Model: Adonis-C2		Date: 10-May-01	No.: MB003001
Modified Article: Operation Panel Ass'y		Prepared by: E. Fukuyama	
From: Technical Services Dept., GTS Division			
Reason for Modification:	☒ Parts catalog correction ☐ To facilitate assembly ☐ Part standardization	☐ Vendor change ☐ To improve reliability ☐ Other	☐ To meet standards ()

Model: Adonis-C2		Date: 07-Jun-01	No.: MB003002
Modified Article: Card Cover		Prepared by: E. Fukuyama	
From: Technical Services Dept., GTS Division			
Reason for Modification:	☐ Parts catalog correction ☐ To facilitate assembly ☒ Parts standardization	☐ Vendor change ☐ To improve reliability ☐ Other	☐ To meet standards ()

Model: Adonis-C2		Date: 04-Jul-01	No.: MB003004
Modified Article: LCD		Prepared by: E. Fukuyama	
From: Technical Services Dept., GTS Division			
Reason for Modification:	☐ Parts catalog correction ☐ To facilitate assembly ☐ Part standardization	☒ Vendor change ☐ To improve reliability ☐ Other	☐ To meet standards ()

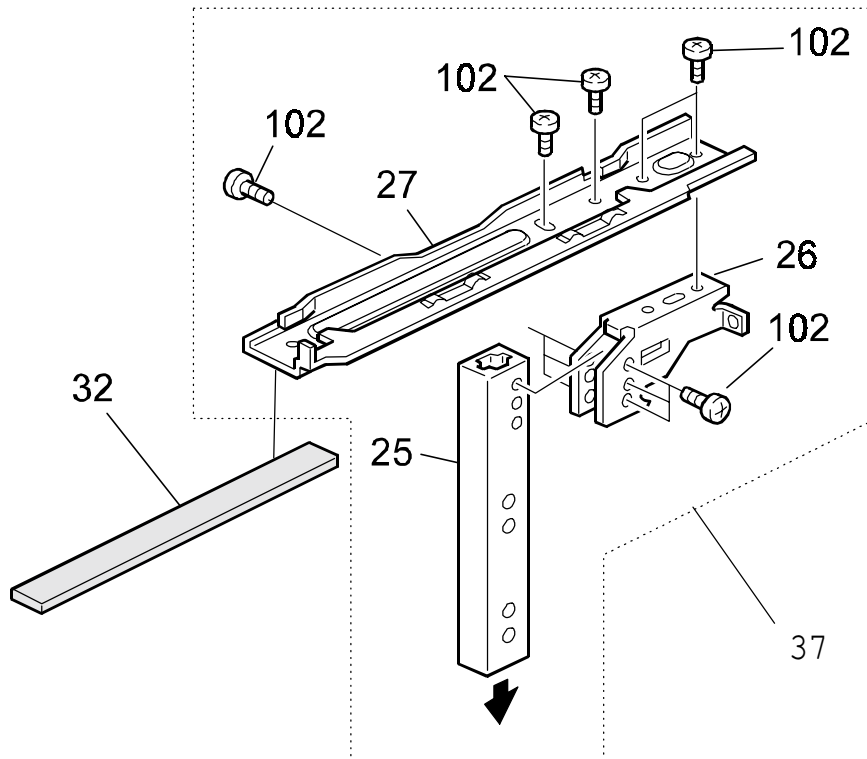
To reinforce the Scanner Arm, the thickness of the Guide Plate has been increased and the shapes of the Supporting Plate and Scanner Arm Unit have been changed. In addition, to facilitate easy replacement in the field, a Scanner Arm Assembly has been newly registered, which contains these three components.

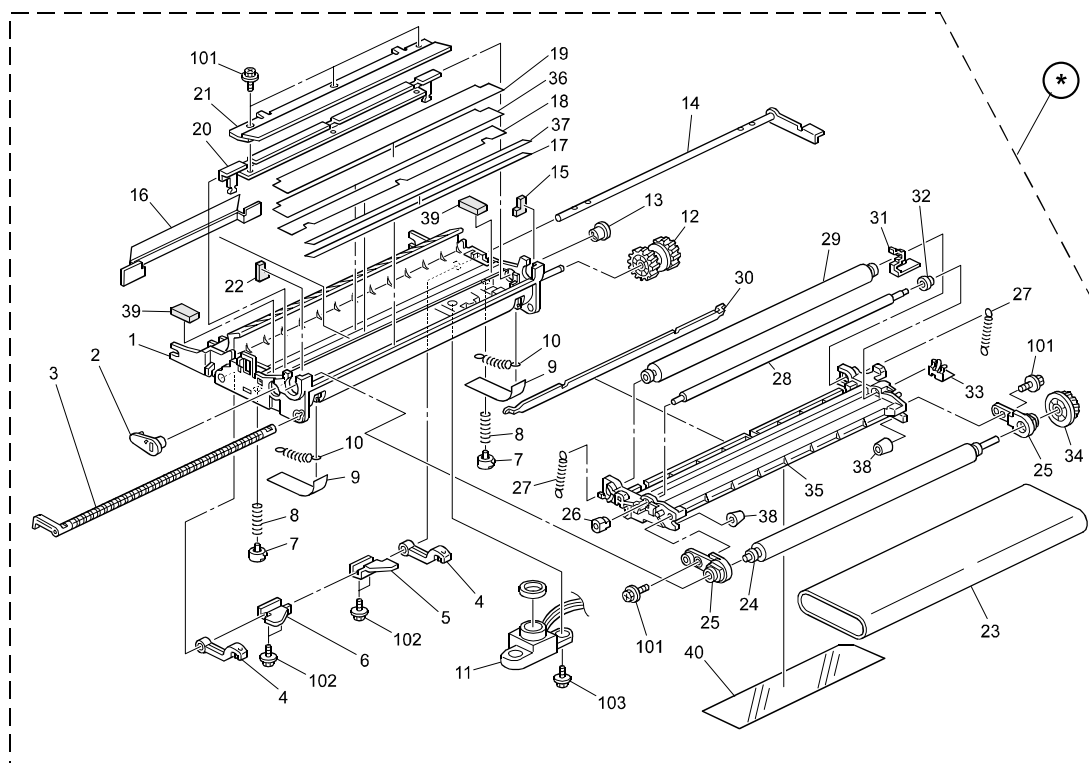
The Right Cover, already registered as an individual service part, has been removed from the "Transfer Unit" service part. Therefore, the new Transfer Unit below is comprised simply of the unit itself.

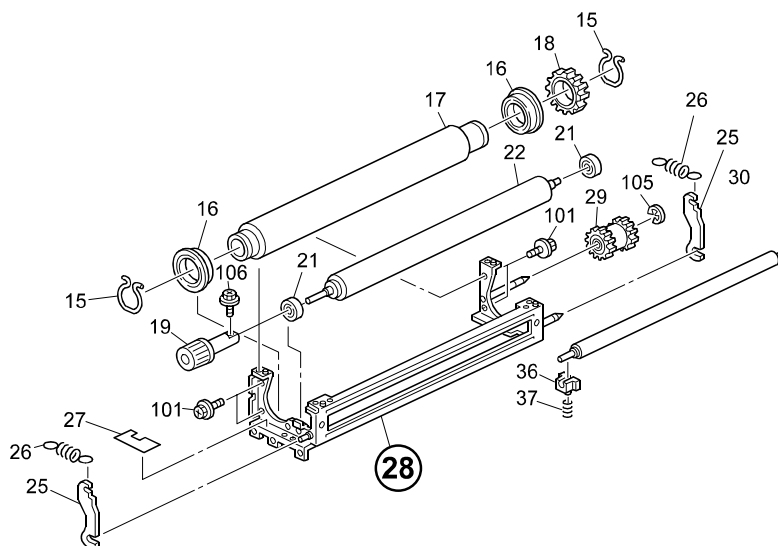
The following has been changed due to a vendor change.

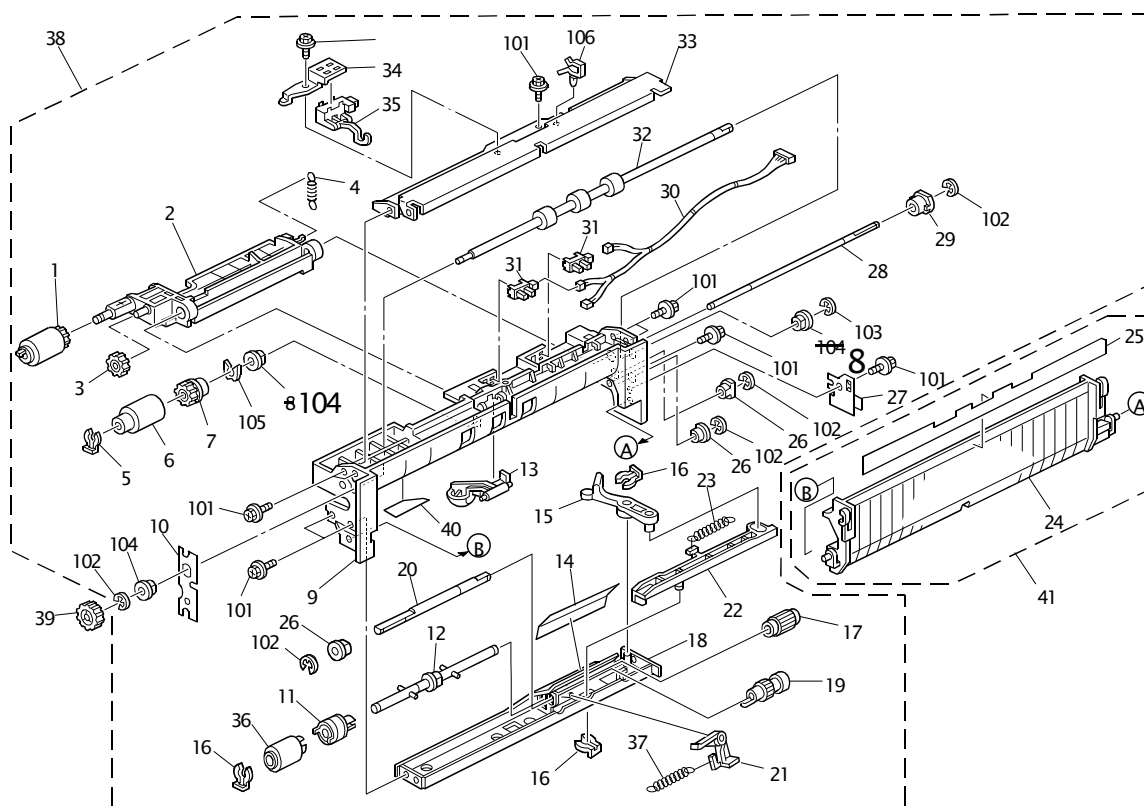
Please apply the following index number correction to your Parts Catalogs.

Part Number	Description	Q'ty	Int	Page	Incorrect Index	Correct Index	Note
AA082070	Bushing – 8x16x7	1		31	8	104	
08053480	Bushing – 6mm	-		31	104	8	(Right side of illustration only).

Important: Make sure to correct **only the large index numbers** shown below. All other index numbers are correct.

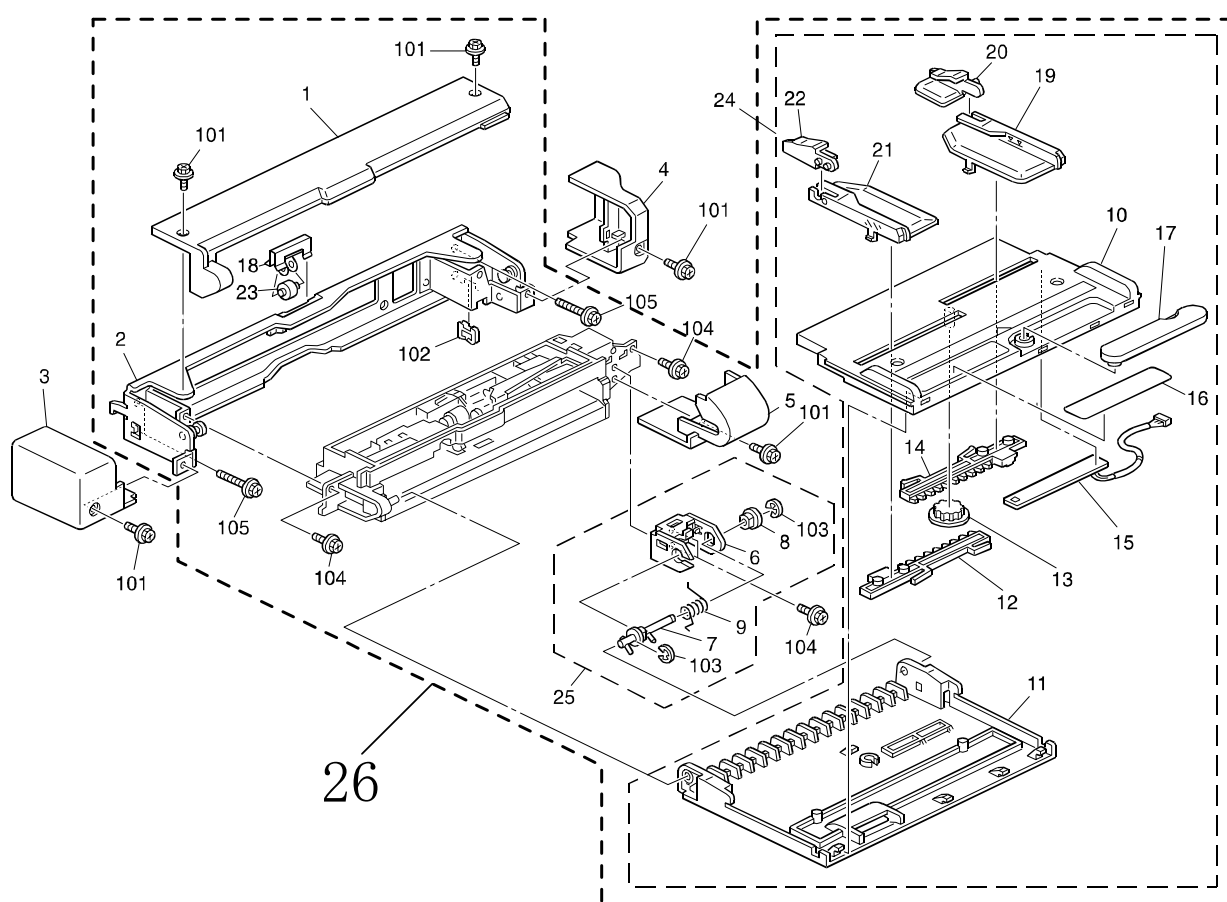
Old part number	New part number	Description	Q'ty	Int	Page	Index	Note
A2326002		Bypass Feed Unit	1-1	O/O	25	26	
→	G0656202	Manual Feed Unit: Sub-Assy

Change/Reason: Parts standardization with the Model A-P3 (G065).
